STATE OF MAINE
DEPARTMENT OF TRANSPORTATION
16 STATE HOUSE STATION
AUGUSTA, MAINE
04333-0016

February 24, 2011
Subject: **Canaan**
Federal Project No: BR-1669(200)X
State PIN: 016692.00
Amendment No. 1

Make the following change to the Bid Document:

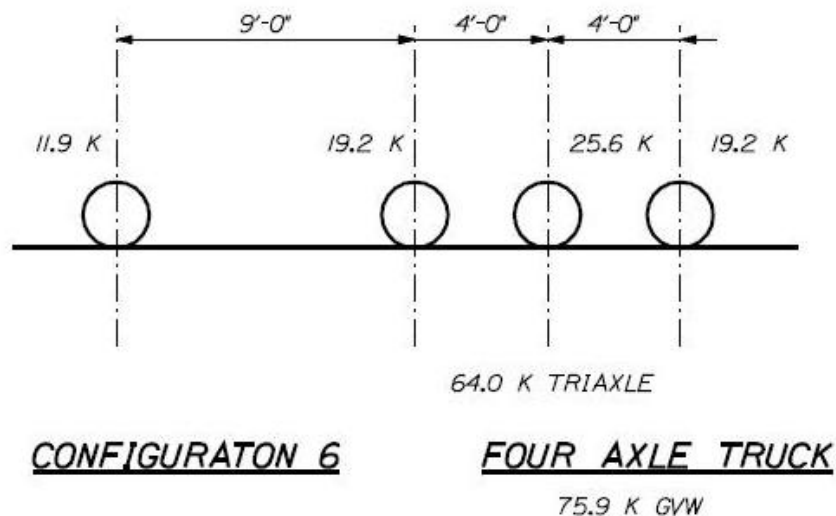
534.30 Design Requirements The Contractor shall design the precast structural concrete structure in accordance with the AASHTO LRFD Bridge Design Specifications, current edition. The design live load shall be as follows: *modified HL-93 Strength I for LRFD method. *(modify HL-93 by increasing all wheel loads and/or axle loads for the Design Truck by a factor of 1.25). In addition, the following Maine legal truck (configuration #6) shall also be checked to insure that the rating factor is equal to or greater than 1.0 (See diagram immediately below).
